February 5, 2025

Subject: Wifi Pole Drilled Shaft Repair Letter
SFCT Cargo Yard Densification Phase 2, Port Miami
Miami-Dade County, Florida

Figure 2: Slump Loss Chart

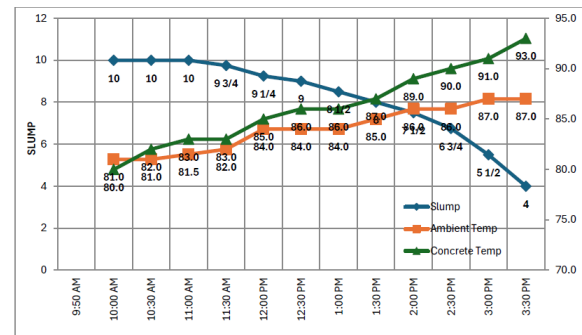
In regard to the second point of concern, the pour took 5.25 hours and the interpolated slump per the concrete supplier's slump test data indicates that initially placed concrete would have a slump of 4 3/4" at the conclusion of the pour (5" minimum at time of placement is required). This poses concerns of disturbing partially set concrete which could lead to compromised structural integrity of the concrete, cracks, or reductions in serviceability. However, the concrete with slump anticipated to be less than 5" was in the bottom of the drilled shaft and only outside of acceptable limits for the final 15 minutes of the pour. This concrete is well away from the limits of disturbance from the concrete placement. It is therefore our finding that concrete within areas disturbed by concrete placement satisfied 5" slump criteria for the duration of the pour. It is our finding that there are no reductions in strength or serviceability associated with the slumps of the concrete during placement.

8.25 cubic yards were placed. The bottom of the shaft is likely to be slightly oversized from the initial excavation. The balance of concrete overpour may be attributed to truck 3 overpouring. It is our finding that the as-built drilled shaft has no reductions in structural functionality or serviceability. We therefore recommend its acceptance so that it may be incorporated into the final structure.
